HIDEOUT, UTAH PLANNING COMMISSION REGULAR MEETING AND PUBLIC HEARING

October 20, 2022

Staff Review of Concept Plan Submittal

Re: Venturi Subdivision – Concept Plan

Exhibit A – Deer Springs Phase 3 Site/Construction Plan

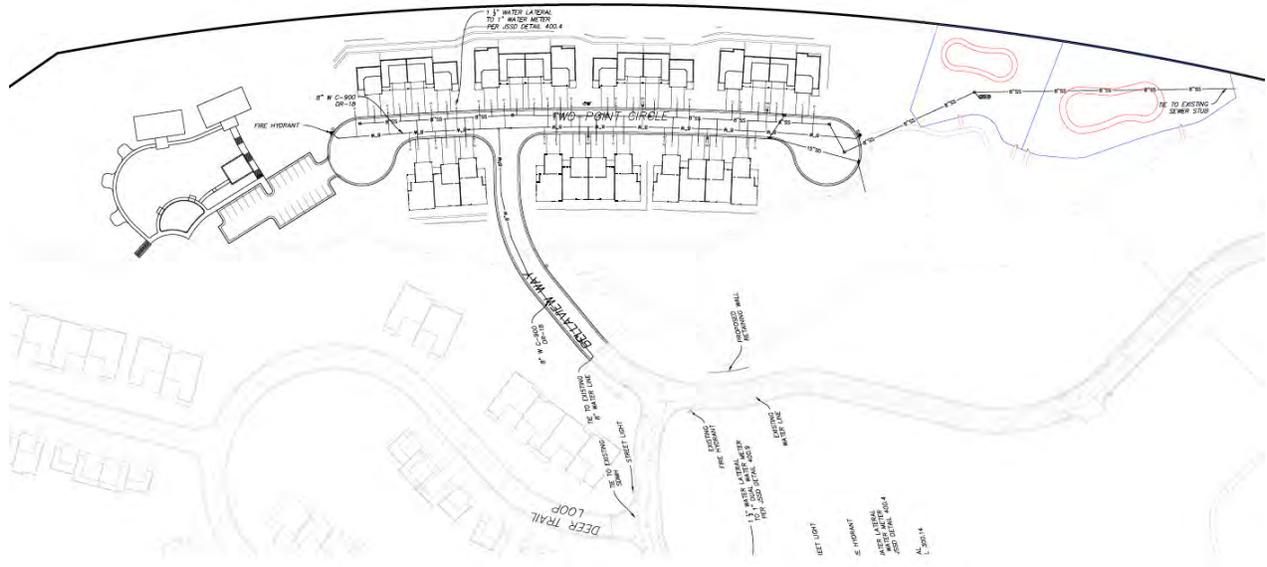
1. Retaining walls: Sheets GR01 – GR04 indicate a series of two (sometimes three) retaining walls tiered at heights exceeding the maximum 5'-0" allowance for a tiered retaining wall structure. These shall be revised to ensure compliance with the Town Code maximum allowed heights.
2. Park and Open Space: The Applicant must provide a signed commitment to begin construction of the proposed park and open space amenities as per the Master Development Agreement (MDA) – Section 7.6 and pp. 90 – 92. The MDA requires the park and dog park to be completed prior to the issuance of any Certificates of Occupancy for Phase 3.

5. Streetscape amenities; lighting, signage, etc. should be provided on the construction plan set. These should match Deer Springs Phase 1, 2a and 2b.
6. Road Widths: The asphalt shall be 26'-0" wide plus curb and gutter; per recent recommendations by the Town Planner and Engineer, a paved bike lane should be incorporated into all new rights-of-way construction.

Map of Proposed Rezone and Surrounding Area

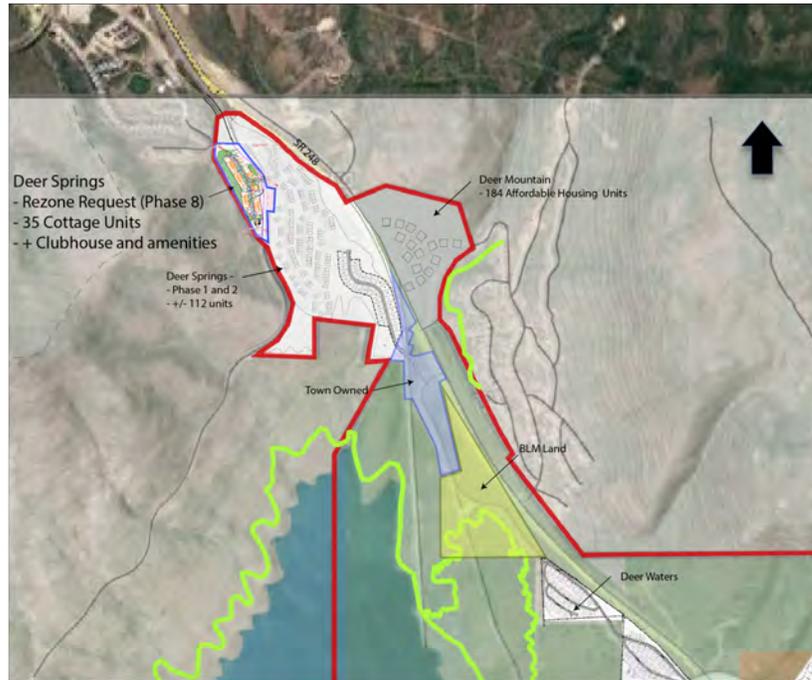
- The 2017 Master Development Agreement (MDA), updated in 2021, allows for 30 units on this site and would have to be amended to allow for additional density for this concept plan.

- The new Zoning Code subdivision standards require sites with greater than 30% slopes to meet additional site planning criteria including: changes to existing grade greater than 5'-0" on more than 10% of the site require moving proposed lots/structures away from the steepest slopes on site, possible increased setbacks, possible reduced massing, visual analysis submittal, etc.

- The MDA does not allow for a clubhouse on this site and would have to be amended if the Planning Commission.
- The excess parking as proposed will require significant grading of the site, and new retaining walls, to level grade for these spaces.

- Retaining walls for the cottages on the south side of the property require a 27'-0" retaining wall per the draft concept plan. The Zoning Ordinance allows for a maximum of two 5'-0" retaining walls spaced five feet apart.

Exhibit A

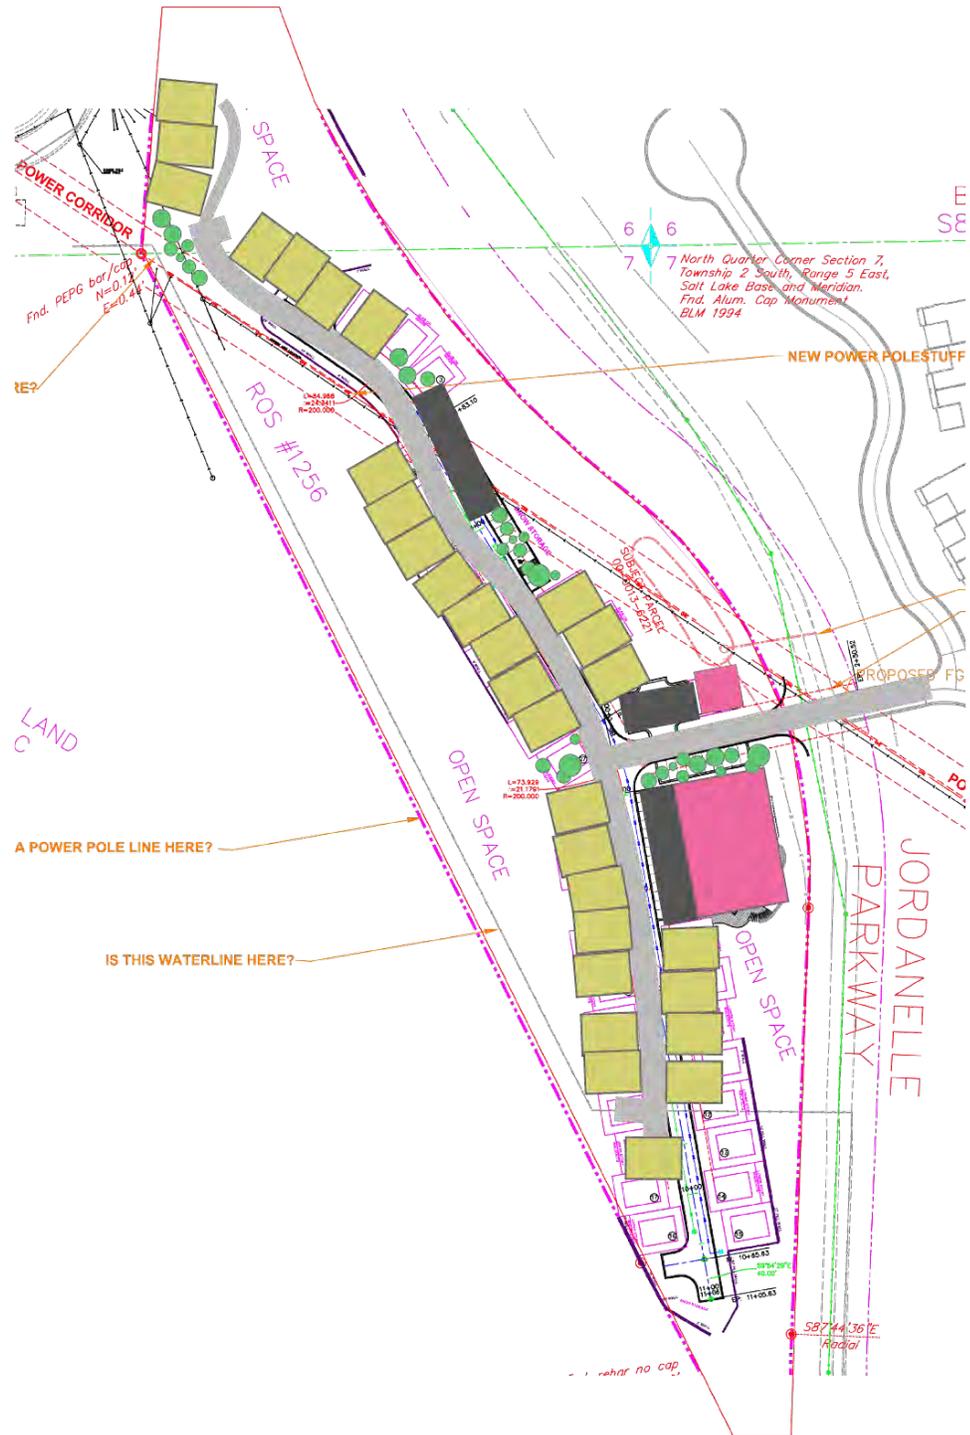
The attached exhibit by staff is a very draft revision of the submitted site plan that may accomplish the following:

- Reduction in size and number of retaining walls
- Reduction in excess parking
- Increased staggering of lot/structure layout
- Increased opportunities for preservation of existing landscape and/or open space pockets
- The concept plan should consider combining the club house with the neighborhood commercial (café, etc.) mix uses, conserve space and share parking

Submitted Concept Plan Package
September 29, 2022

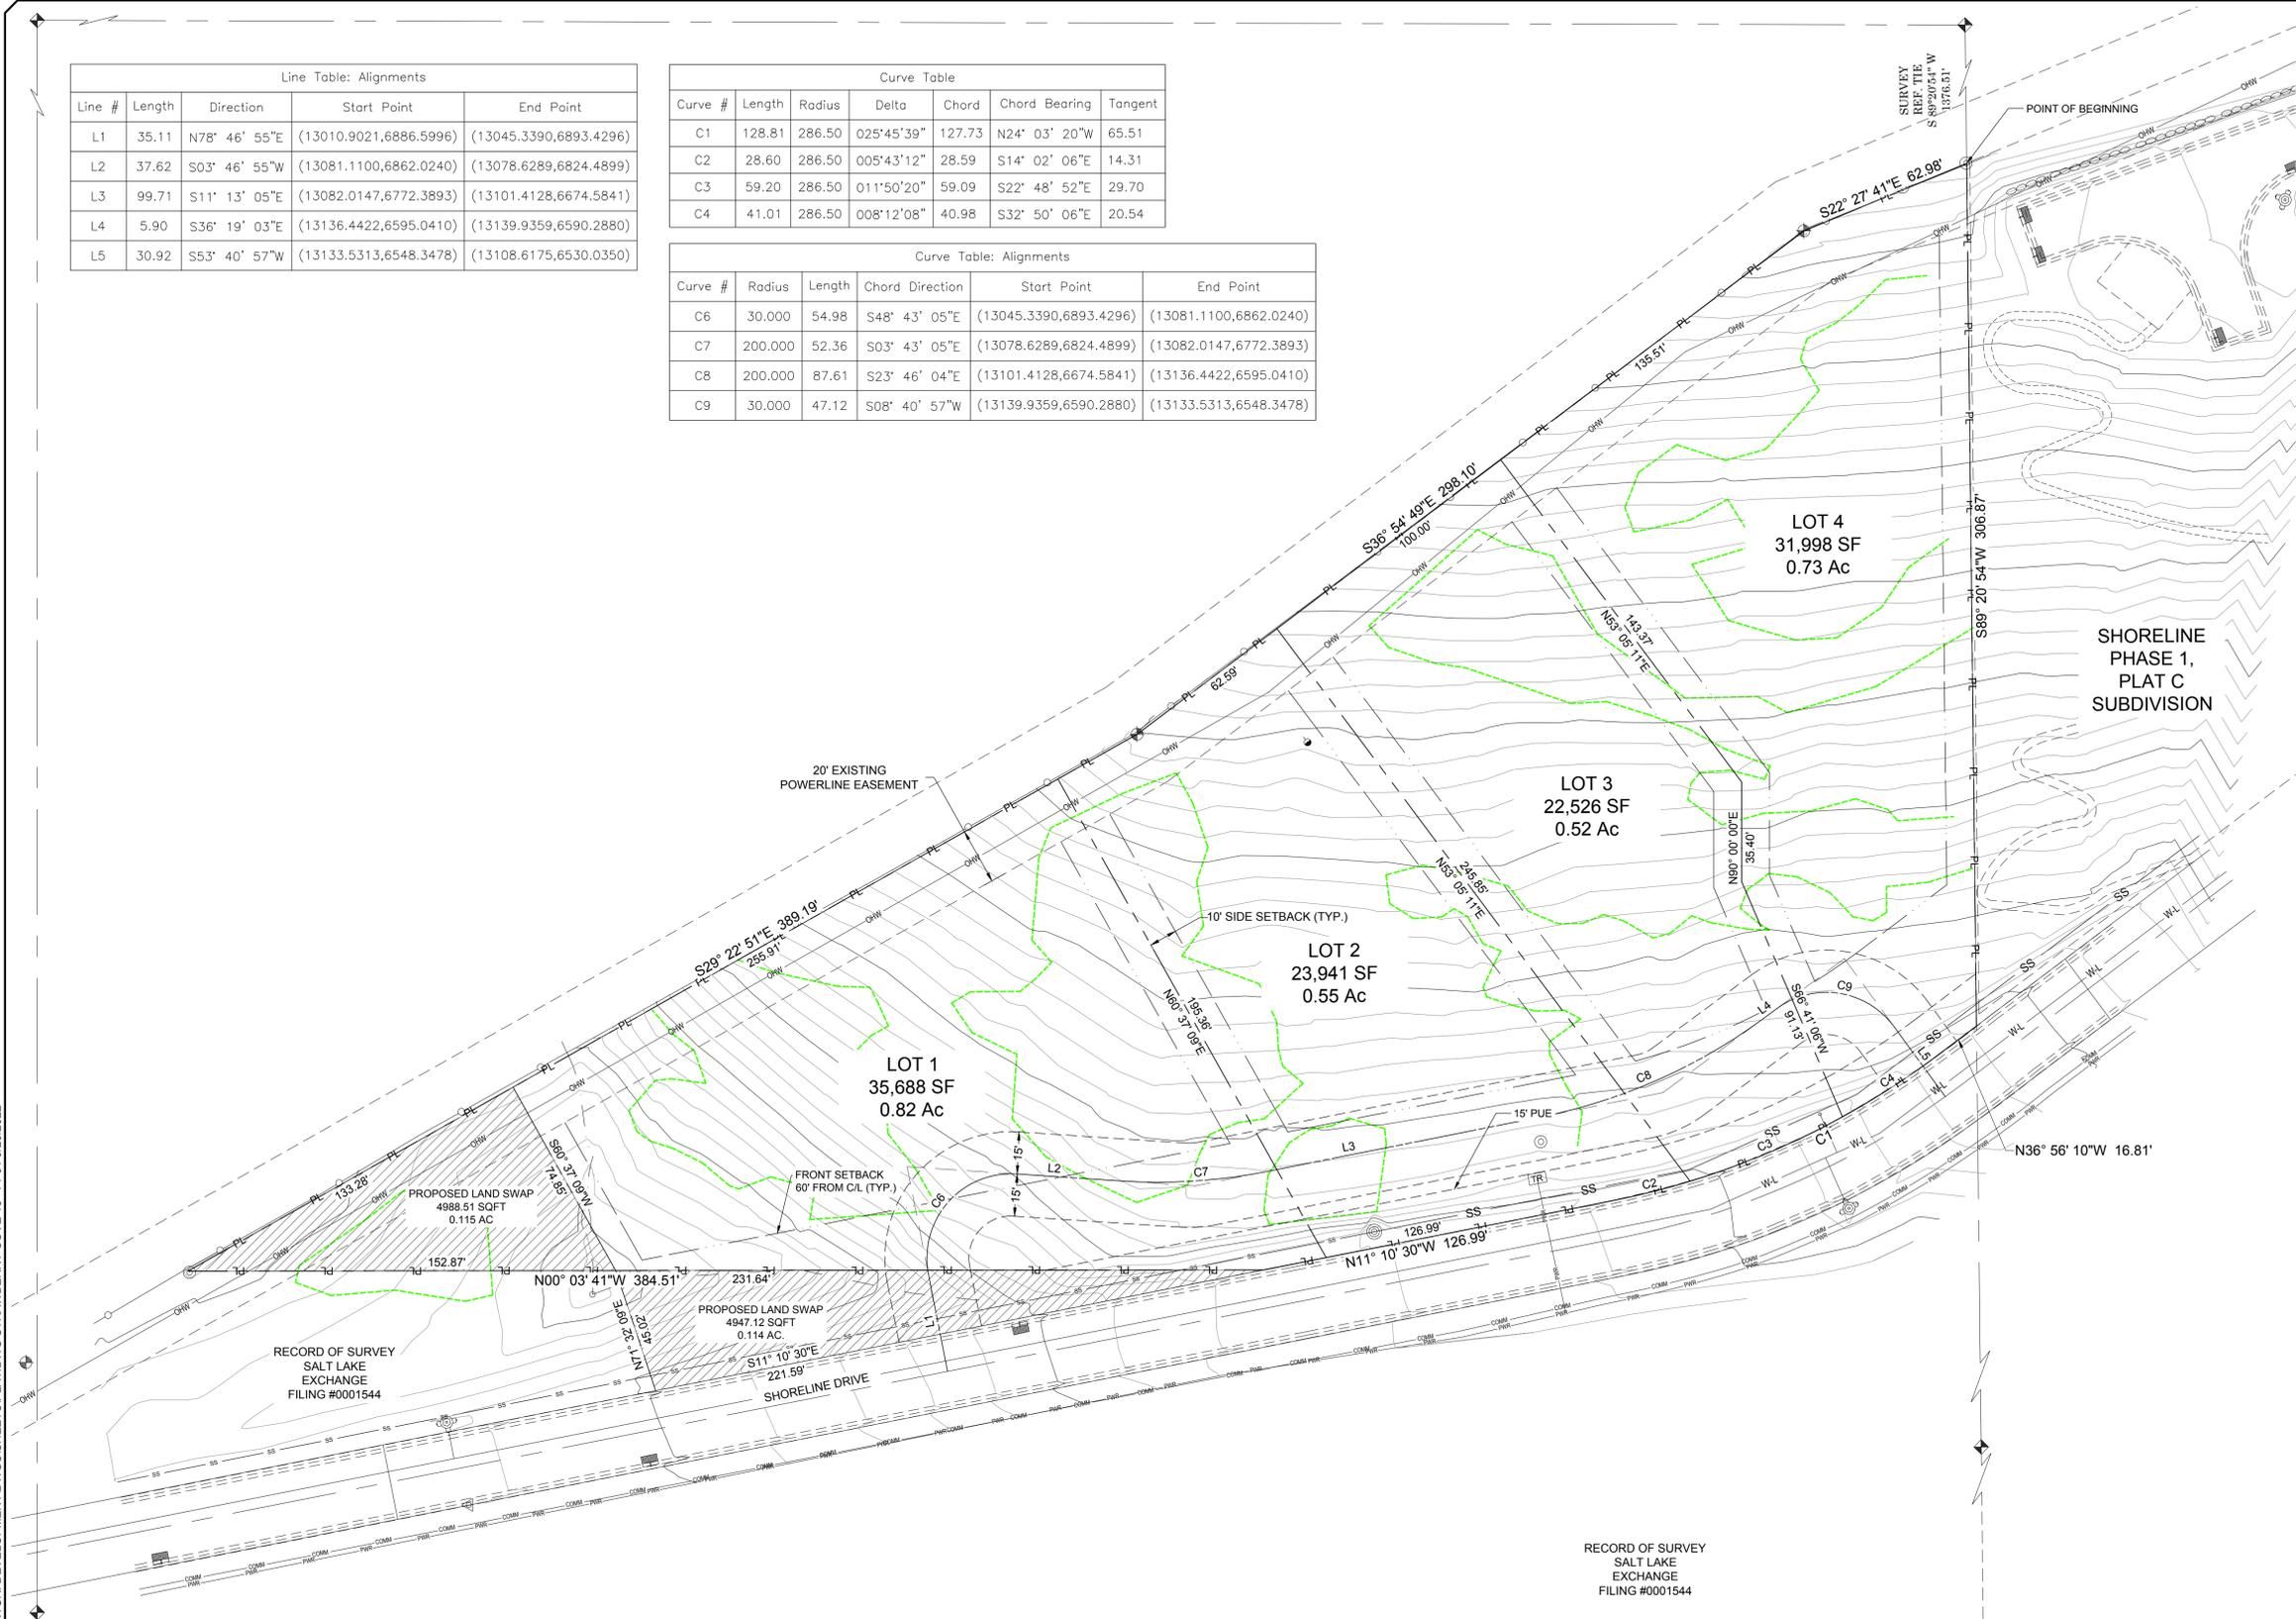
- Does the Planning Commission support the resulting up-zone that the concept plan would require? The single-family product, with 70% open space per lot as originally envisioned for this area, provides for housing type variation and differentiation in this area that is overwhelmingly duplex product.
- The slopes in this area are quite steep (much of the site exceeds 30% slopes) and will require significant grading and the removal of native vegetation
- Retaining walls for the cottages on the south side of the property require a 27'-0" retaining wall per the draft concept plan. The Zoning Ordinance allows for a maximum of two 5'-0" retaining walls spaced five feet apart.

- This concept plan does not include connecting North Shoreline Court to North Shoreline Drive as recommended by the Town Engineer and EMS.
- The Applicant shall confirm that proposed Lakeview Drive will be a private road and not maintained by the Town. The Applicant shall confirm the length of the proposed private road. It appears to be greater than 250' and must meet EMS/Fire Marshall requirements.

- Snow storage areas appear to be too small, located on steep slopes, and not easily accessible to snow plows.
- The Applicant shall provide information regarding stormwater retention information.

- The Applicant must provide the total length of the proposed road.
- The radii at each end of the road should be increased to improve access for EMS vehicles.
- Provide better snow storage locations that are more accessible.
- The Applicant shall confirm the road is intended will be designated a private road.

VENTURI PLAT A SNOW STORAGE PLAN

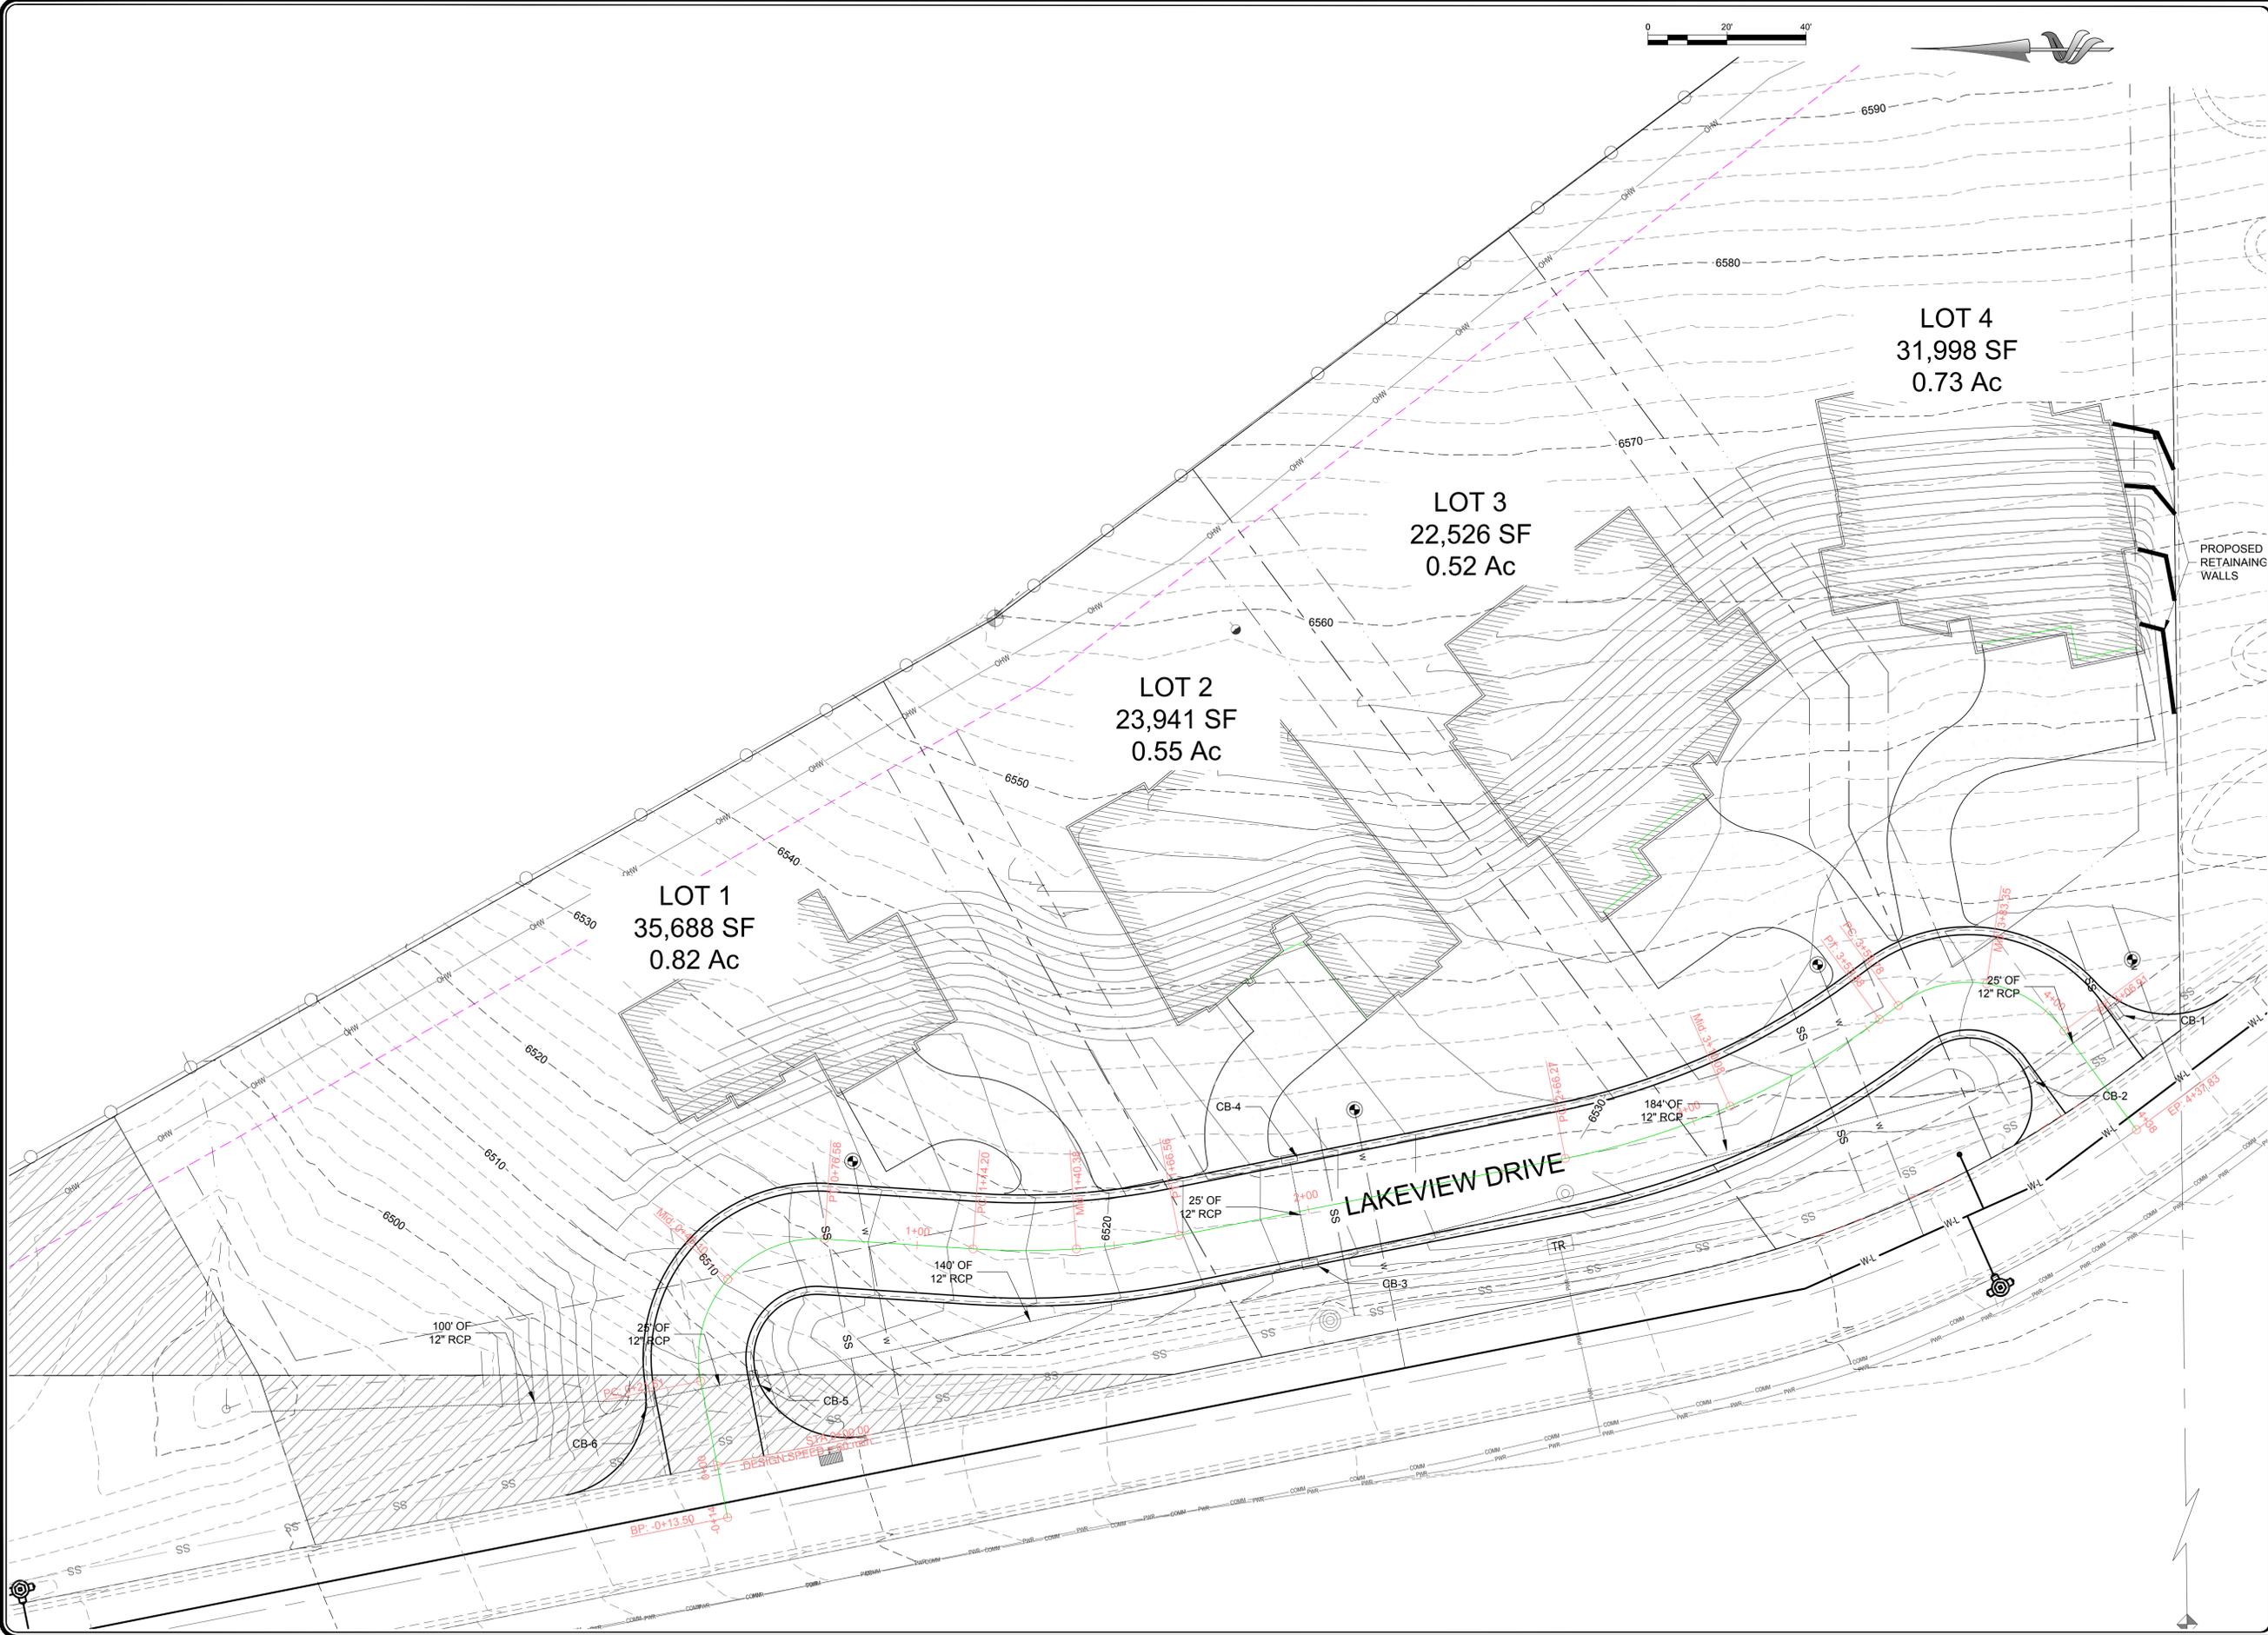
- They show the access easement (or drive) at 30'. The smallest ROW in the code is 51'.
 - If discussions have been had to only have an easement for the road, the smallest cross section, the neighborhood road is 31' from top back of curb to top back of curb. They show 30'.
- The storm drain is smaller than we will accept. 18" is necessary for maintenance.
- We'll need a simple drainage report for this project.
- What do the green lines mean on Sheet 2?
- Can be resolved at final, but a couple of the scales are wrong.
- There are over 30% slopes on the N end of the property. Those should be excluded with a building envelope.
